WILDWOOD RESORT  
990 LAKE WHATCOM BLVD.  
SEDRÖ WOOLLEY, WA 98284  
TYPICAL LOT DECK & CANOPY ENLARGED SITE PLAN

SHEET CONTENTS  
LOT-62 DECK AND CANOPY  
ENLARGED SITE PLAN

Job No.	11176	Rev.	1	Date	
Dwg No.	S1	Issue For Construction	1	3/12	
Project	Deck & Canopy Wildwood Resort - Lot 62 990 Lake Whatcom Blvd - Sedro Woolley, WA Plans, Sections, Elevations & Notes				
<b>DVDI Engineering, Inc.</b> Structural Engineering (360) 933-1345

SITE PLAN

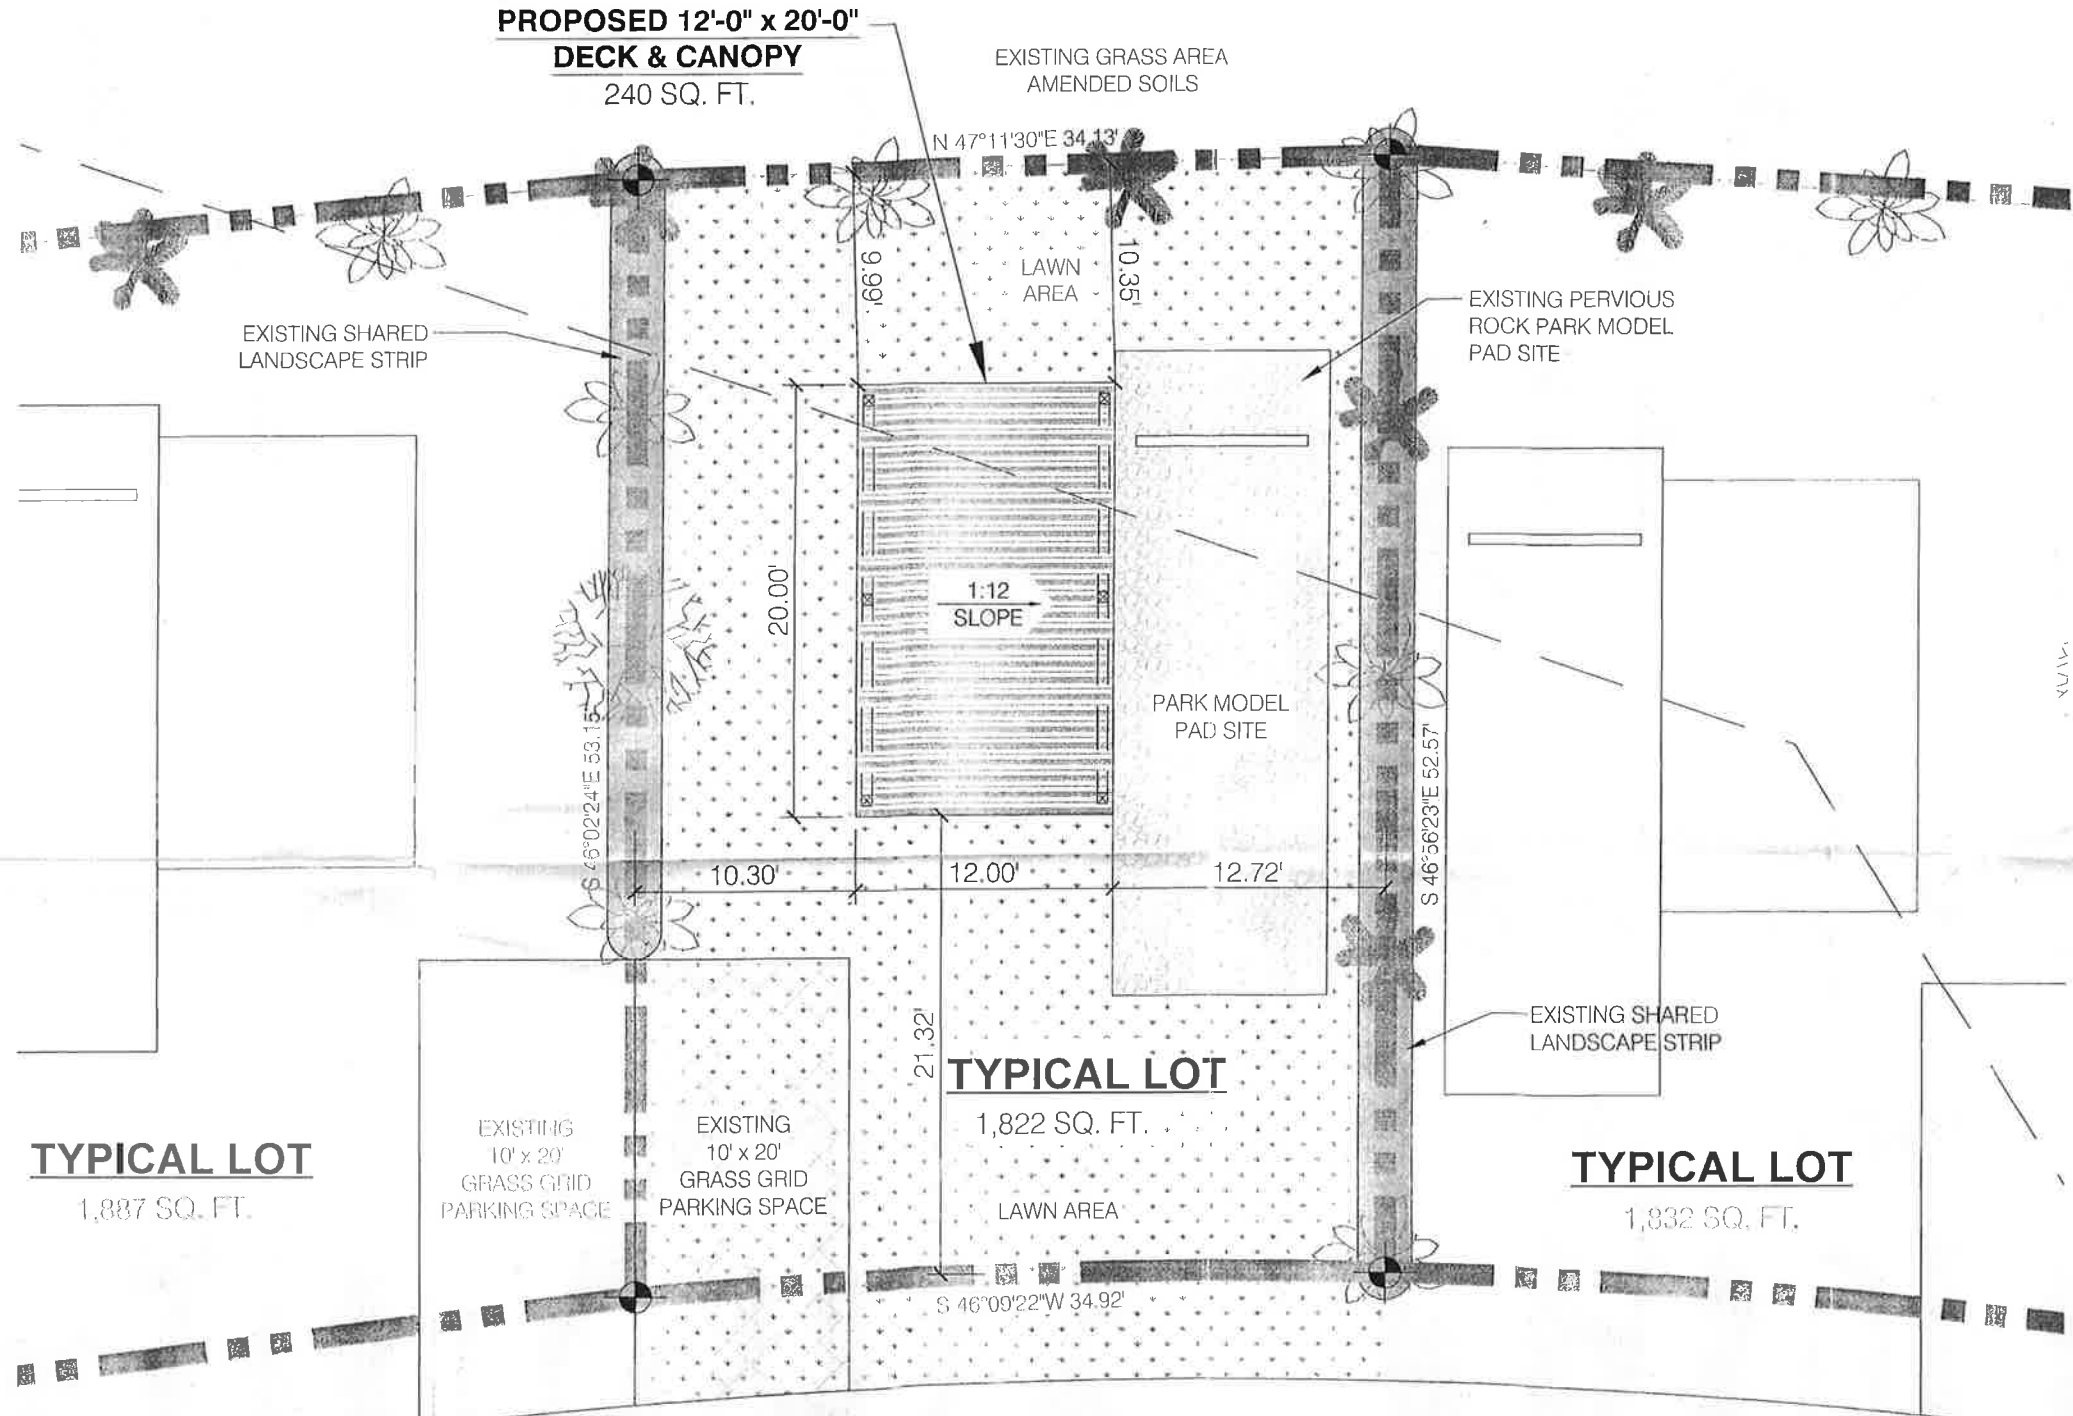
APPROVED  
No needed  
MSK 4/9/12  
EROSION & SEDIMENT CONTROL PLAN

APPROVED  
OK per copies of  
MSK 4/9/12  
IMPERVIOUS SURFACE REQUIREMENTS

APPROVED  
OK per copies of  
MSK 4/9/12  
STORMWATER MANAGEMENT PLAN

Erosion and Sediment Control (ESC) inspection required at time of initial site prep. Call 738-2520 to schedule an inspection. Future inspections may be delayed until ESC requirements are met.

All exposed soils shall be mulched within 48 hours of initial clearing. Excavation piles shall be covered with secured plastic covering when not being worked.

Clearing activity as defined in WCC 20.97.054 that will result in exposed soils exceeding 500 square feet shall not be permitted from October 1 through May 31.

PRE-CONSTRUCTION MEETING REQ'D PRIOR TO CONSTRUCTION. Call Whatcom County Planning & Development Services at (360) 738-2520 to arrange for a pre-construction meeting with the Whatcom County Building Inspector.

Refer to Engineer's "S" pages for structural items.

For all preservative-treated and fire-retardant treated wood:  
• Connections shall be treatment rated.  
• Fasteners shall be hot-dipped zinc-coated galvanized, stainless steel, silicon bronze or copper. IRC Section 317.2

**ROOF FRAMING PLAN**  
SCALE: 1/4"=1'-0"

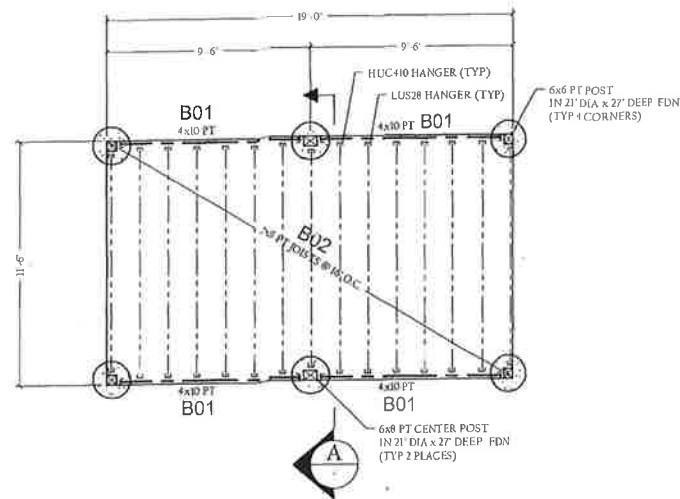
PROVIDE APPROVED ANCHORAGE OF BEAMS OR GIRDERS TO POSTS PER IRC SECS R407.3, R502.9 & R502.11.

FASTENERS IN TREATED WOOD SHALL BE HOT-DIPPED GALVANIZED, STAINLESS STEEL, SILICON BRONZE OR COPPER (IBD SEC 2304.4.3)

WILDER SHALL BE PROTECTED AGAINST DECAY PER IRC 2304.11

PROVIDE APPROVED ANCHORAGE OF COLUMNS & BEAMS PER IBC SEC 2304.5.7, 2309.7

THIS STRUCTURE TO COMPLY WITH FASTENER SCHEDULE IBC TABLE 2304.8.1

**FRAMING/FOUNDATION PLAN**  
SCALE: 1/4"=1'-0"

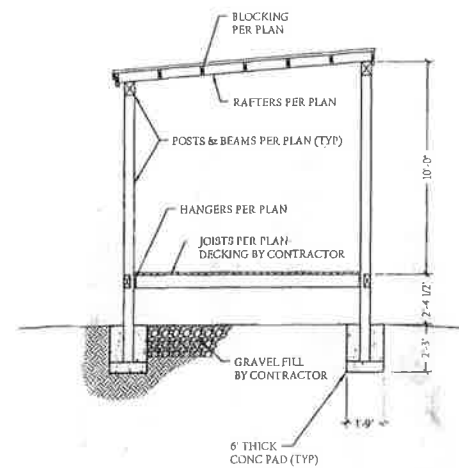
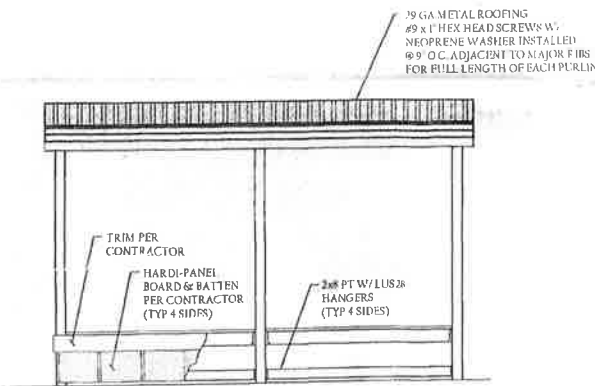
STAIRWAYS AND STAIRWAY LANDINGS, HANDRAILS & ILLUMINATION SHALL COMPLY WITH IRC SEC R311 GUARDS PER IRC SEC R312.

POSITIVE CONNECTION AND TRANSFER OF LOAD FROM ROOF SYSTEM TO LOAD SUPPORTING ELEMENT IS REQUIRED

SOLID BLOCKING REQUIRED AT ALL BEARING POINTS OF FLOOR, CEILING & ROOF SYSTEMS PER IRC SEC 2305.3.5, 2305.3.6, 2305.3.7 & 2305.3.8

PER IRC SEC R317  
All oil producing penetrative & the attached to wood shall:  
• Be protected with a fire-retardant coating.  
• Fasteners shall be hot-dipped galvanized, stainless steel, silicon bronze or copper.

**Gutters and down spouts:**  
All buildings shall provide a concrete method of water disposal for collection and discharge. System shall consist of gutters/couplers and downspouts connected to right line drain, or approved splash blocks.
